DISCRETIONARY REVIEW ABBREVIATED ANALYSIS

Record No.: 2019-006578DRP **Project Address:** 2455 Harrison Street Permit Applications: 2019.0430.9262

Recommendation: Do Not Take DR and approve

The project proposes to demolish an existing one-story automotive repair building and construct a new four-story mixed-use building with laboratory use on the first and second stories, and residential dwelling units on the third and fourth stories.

2451 HARRISON WITH PROPERTY LINE WINDOWS AND NORTH STREET VIEW

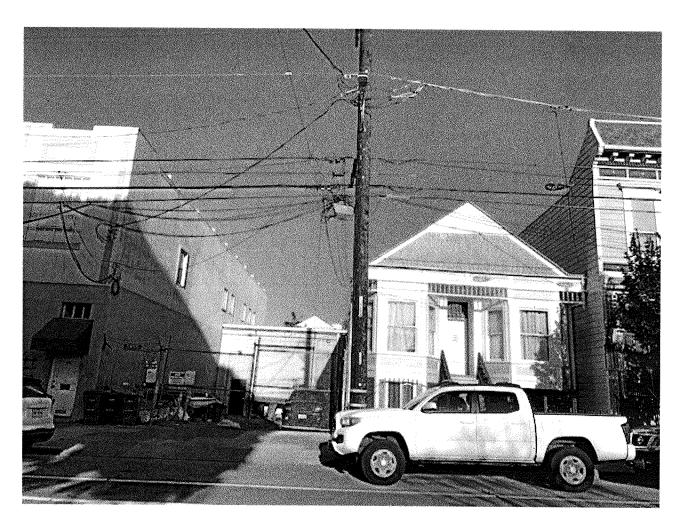
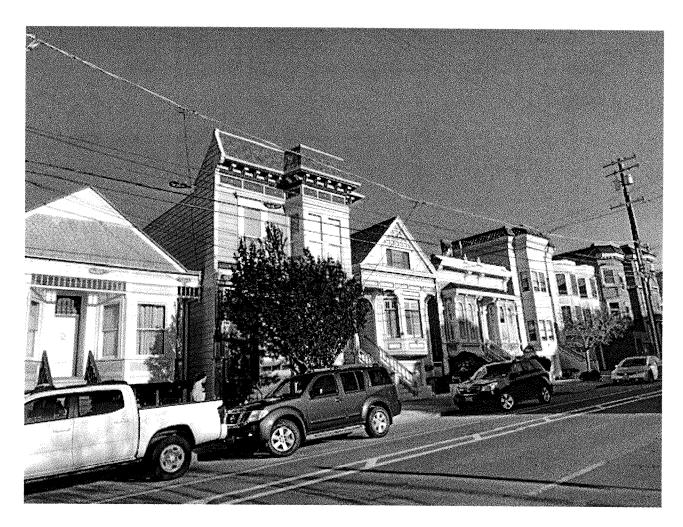
The 2455 building would remove rented bedrooms from the 2451 Harrison building as it is being built to the north property line blocking existing bedroom windows in the property line wall. These windows have been in place since the building was originally built.

2. The building at 2455 Harrison is to the south of my building at 2451 Harrison. At the top of the penthouse, it is 65 feet tall and would cast a large shadow on my roof top solar panels. At their highest point my solar panels are only at a height of 40 feet. The penthouses are on the north side of the building, casting a larger shadow. As California is moving away from natural gas to renewable electricity this will put a tremendous electrical burden on 2451 Harrison going forward. Commencing in 2021 all new buildings will be required to be 100% electric, no gas. 2451 Harrison at certain times of the day sends electricity back into the grid. We have an analysis by our solar energy company that is attached.

- First, the Planning Code does not regulate property line windows (the Building Code does that) and,
- Second, the existing windows the DR Requestor seeks to protect serve an illegal/unpermitted dwelling unit without code required light and air to its bedrooms and living spaces and without legal emergency egress from its bedroom windows.

<u>All windows</u> in the DR Requestor's unpermitted dwelling unit (2453 Harrison Street) are unprotected property line windows, located on the side and rear property lines of that building. They are being used for the express purpose of providing light and air across property lines to illegal bedrooms with no emergency egress, in direct violation of the San Francisco and California Building Codes and the life safety provisions therein intended to provide for safe living conditions.

Estimated Monthly Production

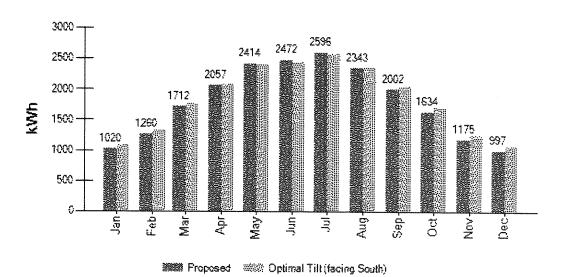
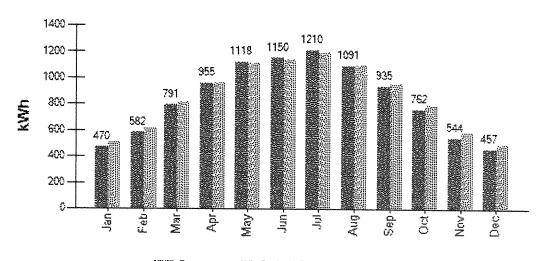
environmental goals. access to sunlight, which fuels their significant financial investment and helps California meet its Any change in neighboring buildings may inhibit solar access and the ability for 2451 to receive

The DR requestor has an extensive solar array on the roof of his property. We applaud the effort and expense he has gone to provide clean power to his building. That array, however is a story and a half below the allowable development height of the subject property. Attempts to protect solar access (especially in the winter months when the sun is low in the southern sky) to his panels would require removal of the proposed top floor at 2455 Harrison, or a significant setback of approximately 10 feet from the common side property line (resulting in a building width of approximately 15 feet). Either approach would result in the loss of (2) dwelling units (and require a variance to dwelling unit mix) or the loss of (3) of the 5 dwelling units.

- >> <u>Given that the Planning Code does not protect direct light access to solar arrays, this hardship and loss of dwelling units to the subject proposal is unjustified and unacceptable.</u>
- 2. What alternatives or changes to the proposed project are you willing to make in order to address the concerns of the DR requester and other concerned parties? If you have already changed the project to meet neighborhood concerns, please explain those changes and indicate whether they were made before or after filing your application with the City.

PROPERTY LINE WINDOWS AT 2451 HARRISON (DR APPLICANT)

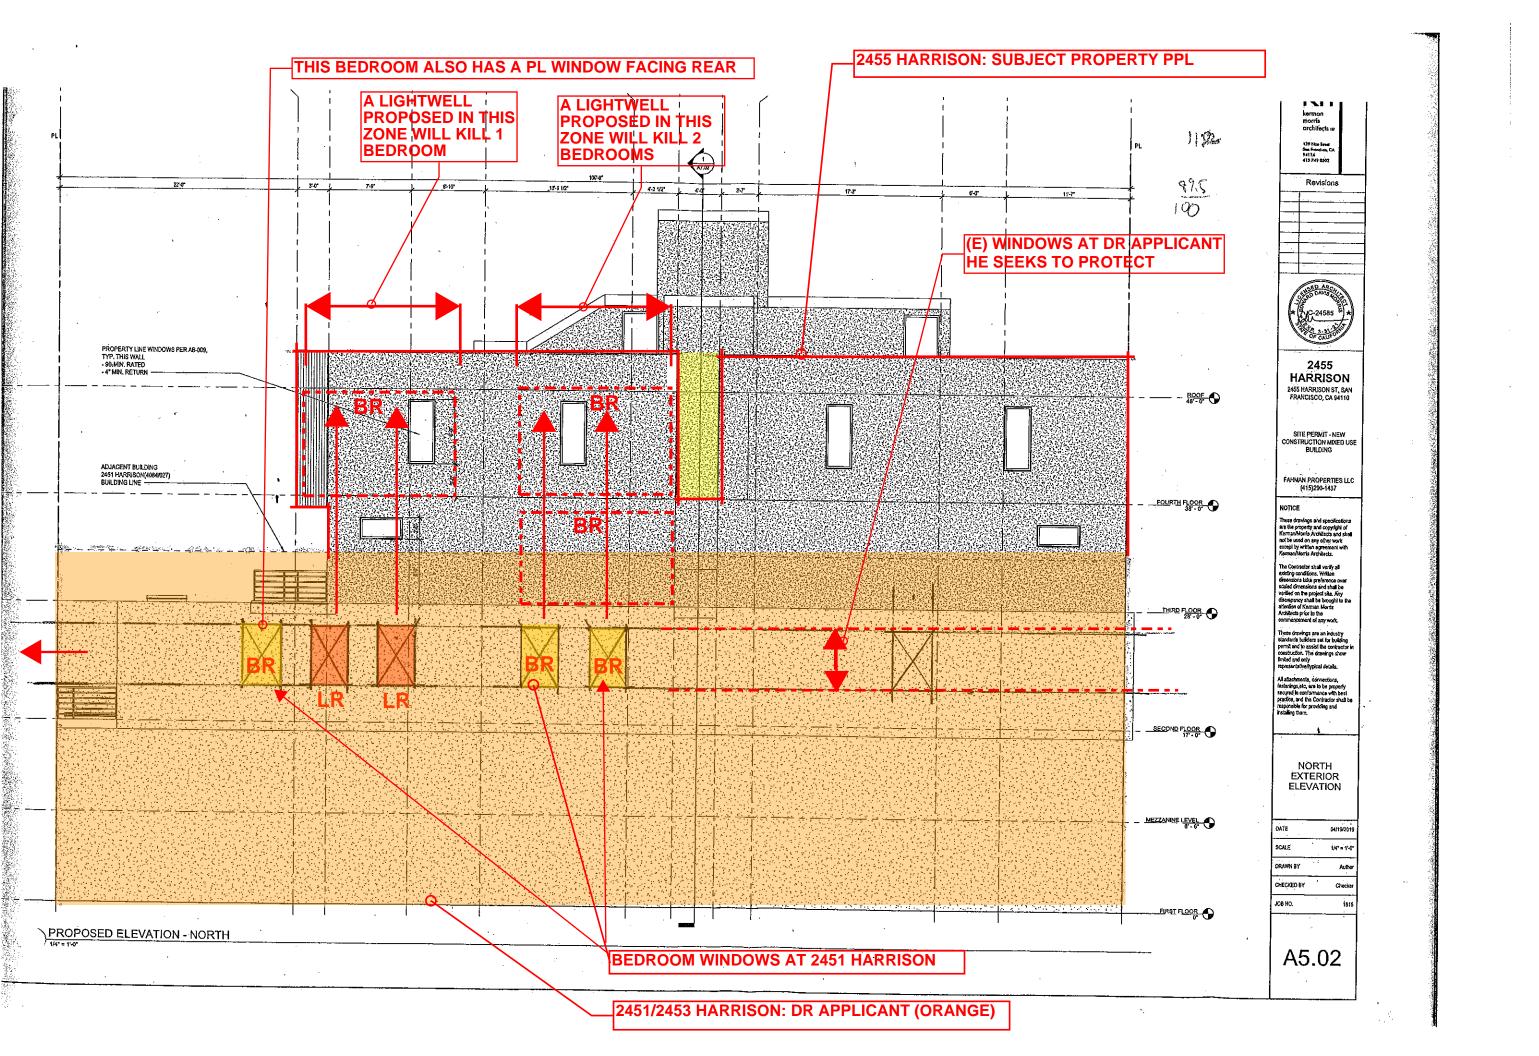
- 1) The building is too tall;
- 2) its construction would "remove existing rented bedrooms from the 2451 Harrison building," as this building's windows are on the common property line; and
- 3) the additional height would cast shadows on the extensive photovoltaic array on the DR Requestor's building.

- Property line windows must be fixed (cannot provide ventilation) and fire rated,
- they <u>cannot be used</u> to provide "<u>required light, and ventilation, required egress, or for required emergency rescue"</u> for any room, especially a bedroom; and
- a recorded statement must be filed with the City Recorder stating that said openings will be "closed or protected with approved fire resistive wall construction" should the neighboring property (in this case 2455 Harrison) be "improved in such a manner that the openings no longer comply with the provisions."

>> The DR Requestor should correct code violations on his own property to provide adequate light and air and exiting to his tenants instead of asking the Sponsor of 2455 Harrison to diminish a code complying design which delivers 5 new residential units.
